UNITED STATES PATENT AND TRADEMARK OFFICE

Office Action Summary	Application No. 10/587,445	Applicant(s) RAMSAUER, DIETER	
	Examiner EMILY M. MORGAN	Art Unit 3677

DETAILED ACTION

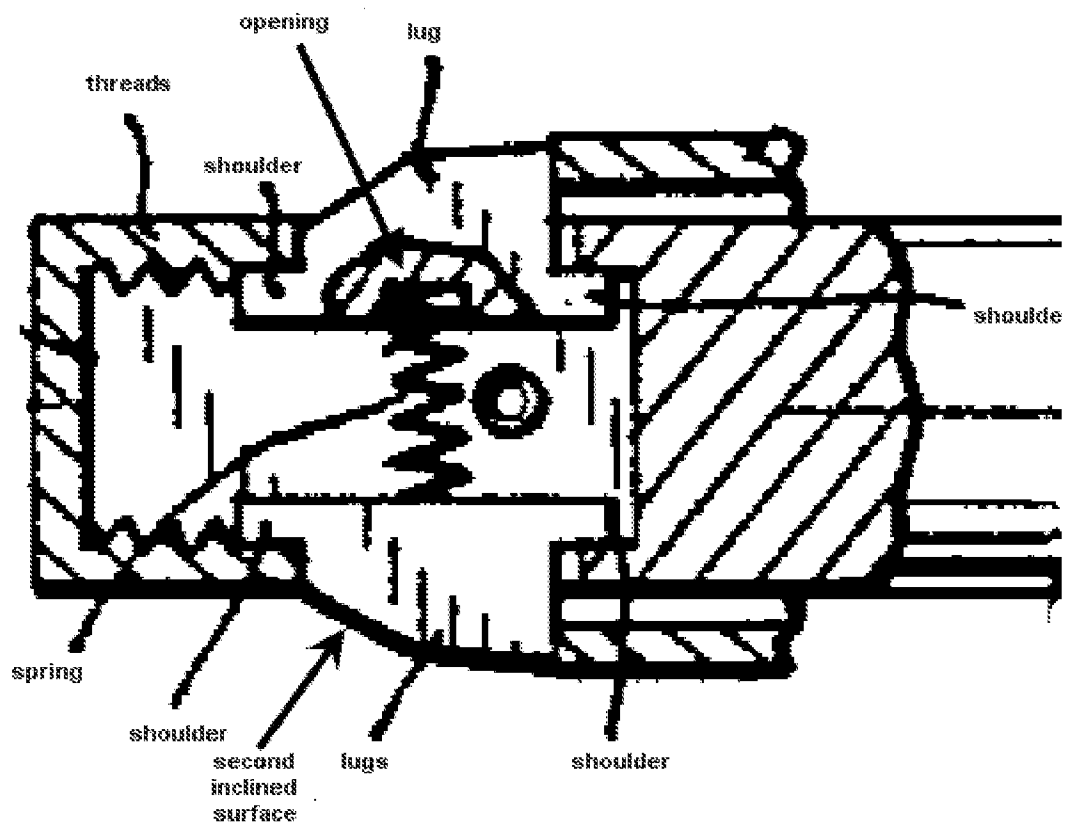
a head part 36, such as a flange, which overlaps a rim of the opening of the thin wall on an outer side (figure 2);

a body part 35 which proceeds from the head part 36 and can be pushed through the opening in the thin wall (figure 2); and

a holding part (lugs 40) which is carried by the body part 35, supported on another rear side of the thin wall (figure 2), and is separate from the body part 35;

said holding part 40 being formed by holding elements (lugs) which project in a resilient manner (via spring 41) from the body part 35 in the direction of its outer surface (figure 5) and whose free end has a second inclined surface 42 which enables the holding part and the body part to be pushed through the opening, the inclined surface being inclined with respect to a plane of the thin wall (figure 1);

wherein the holding elements (lugs) are formed by two flat metal pieces lying next to one another, each metal piece having a rectangular opening or breakthrough (for the lug to expand through the surface of the attachment device), these two openings or breakthroughs together forming a rectangular space which receives a spiral pressure spring 41 by at least a portion of its diameter.

Please see the designations of figure 5, as shown below. Young discloses a singular inclined surface on each holding part, which allows for easy insertion. Young does not disclose a second inclined surface.
